Revised map and exhibits

DRMS Permit M-77-193 Amendment 05
Exhibit C
Pre-Mining & Mining Plan Map
for T.H.E. Aggregate Source
Tunnel Drive
Granite Products Mine

RE: MINE PLAN REVISIONS FOR USBLM MINERAL SALES LANDS, PERMIT
#M77-193

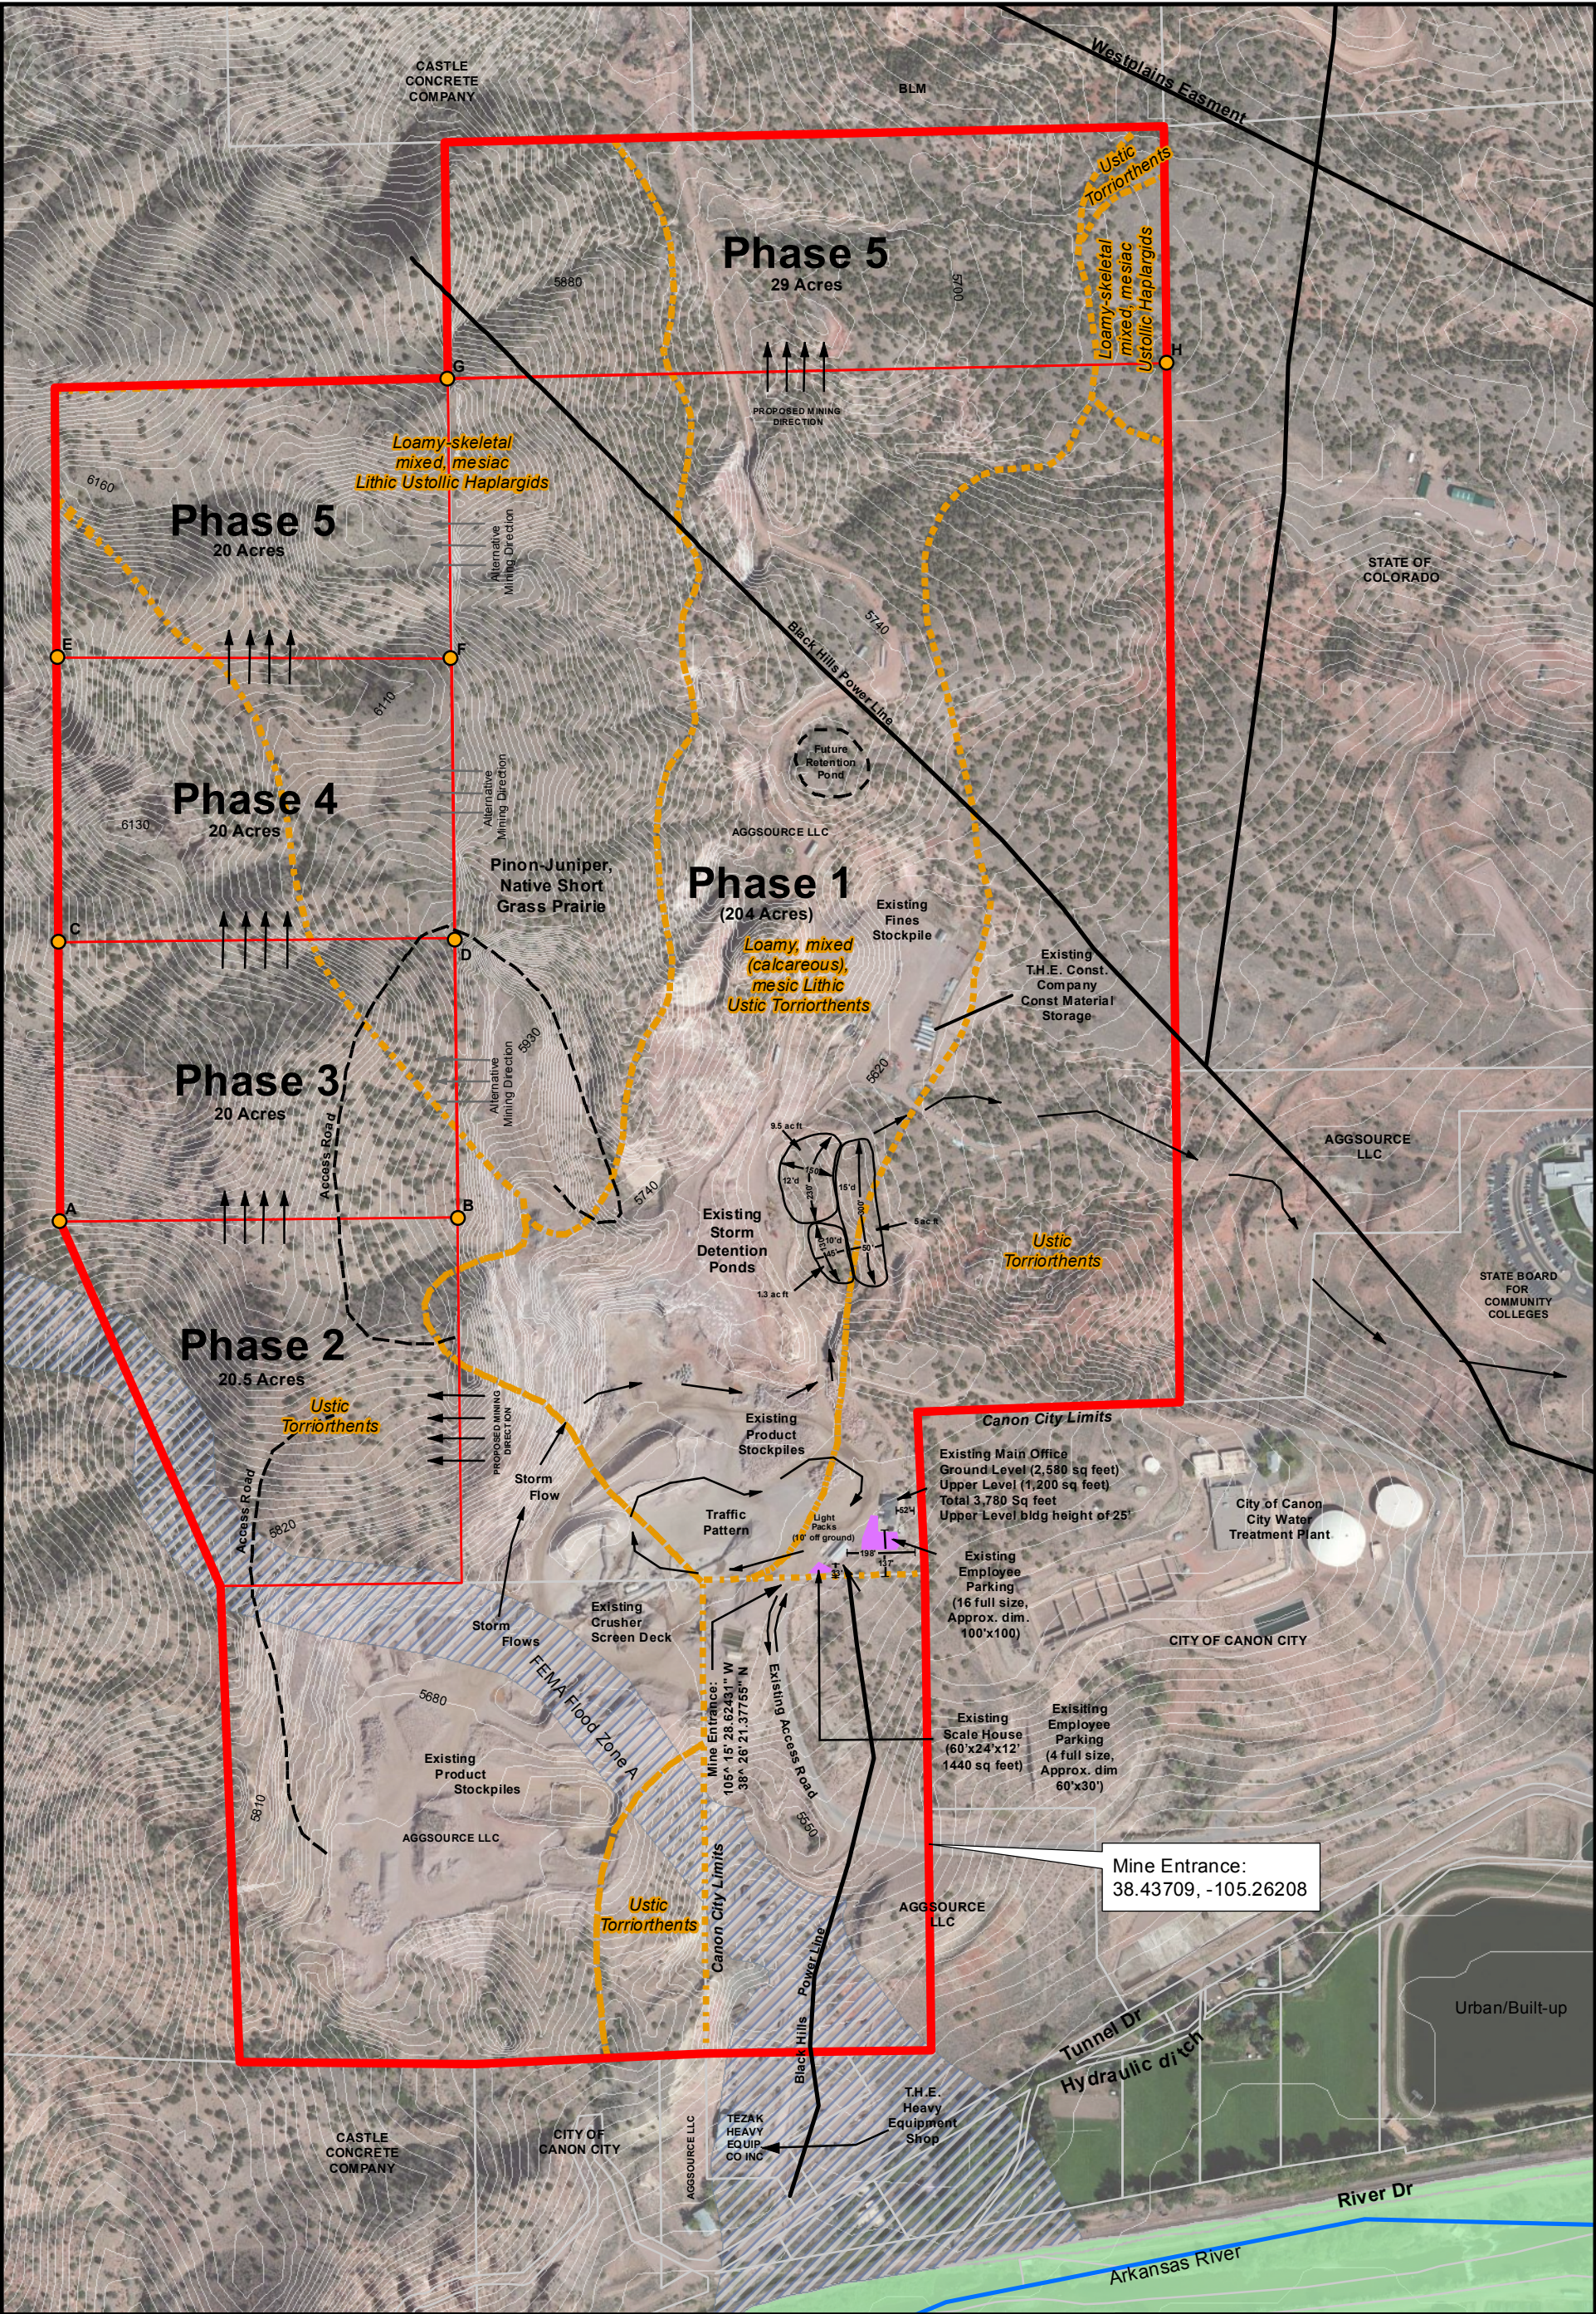
Please find attached map and exhibits that have been revised to reflect recent conversations you and Randy have had regarding bonding estimates and statements made in the mine plan narrative that best reflect the specifications and final reclamation configurations of the highwall benches. If you have any questions regarding these revisions, please do not hesitate to contact me. I will deliver hard copies of these revisions to the Fremont County Clerk and Records office in Canon City.
